*McDonnell Douglas
Helicopter Company*

NOTICE NO. HN-91

SERVICE INFORMATION NOTICE

SUBJECT: MODIFICATION FOR SEATING AND BELTS FOR (4) KIT INSTALLATION,
PN 369H90035-501 - ADDITION OF HEAD AND BACK RESTRAINT PANELS

Figure 1. Installation of Head and Back Restraint Panels and Attach Hardware

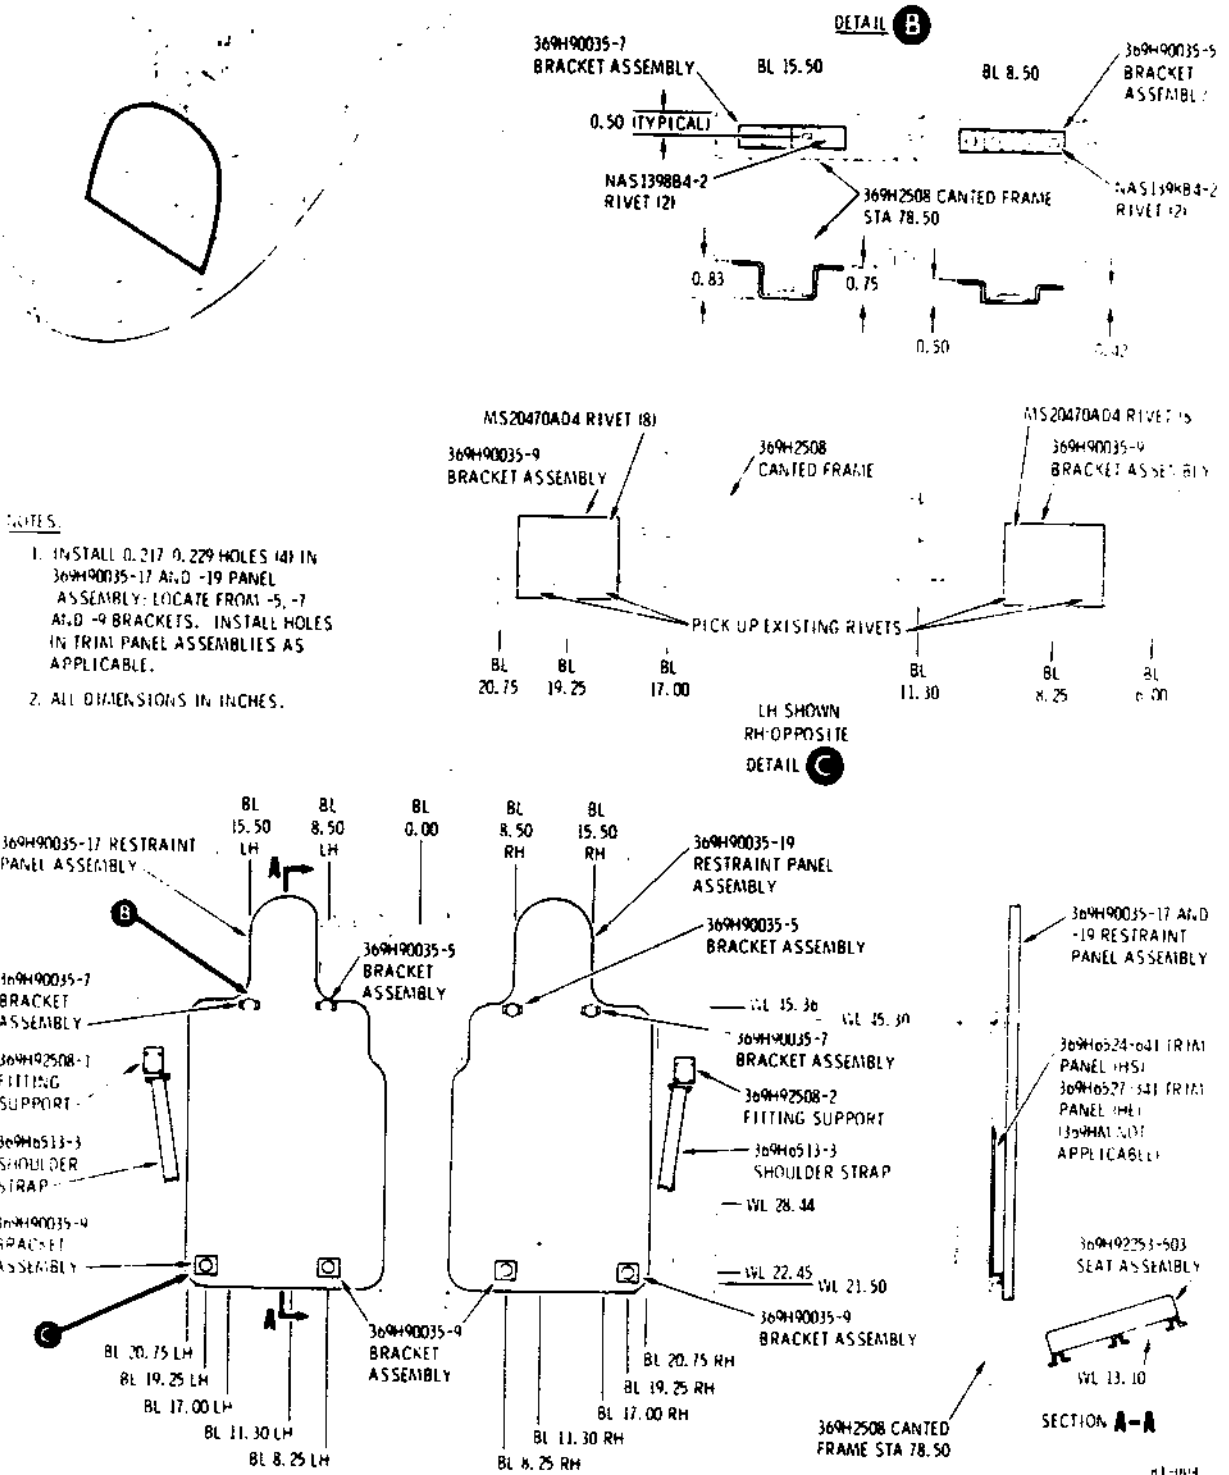
- d. Install 369H90035-9 bracket assemblies (two each LH and RH sides) on Station 78.50 canted frame bulkhead lower section at WL 22.45 and BL 8.25 and 19.25. Use MS20470AD4 rivets. (See Figure 1, Detail C.)

- e. Install 369H90035-7 bracket assemblies (one each LH and RH sides) on channel of canted frame bulkhead upper section at WL 45.30 and BL 15.50. Use NAS1398 B4-2 rivets. (See Figure 1, Detail B.)

f. Install 369H90035-5 bracket assemblies (one each LH and RH sides) on same channel at WL 45.30 and BL 8.50. Use NAS1398B4-2 rivets.

g. Drill four 0.217/0.229 inch diameter holes in aft compartment forward trim panel, as applicable; and in 369H90035-17 and -19 restraint panel assemblies. Locate holes from installed 369H90035-5, -7 and -9 bracket assemblies.

i. Install 369H90035-17 and -19 restraint panel assemblies on bracket assemblies, using NAS514P1032-8 screws and 5724-17 washers.
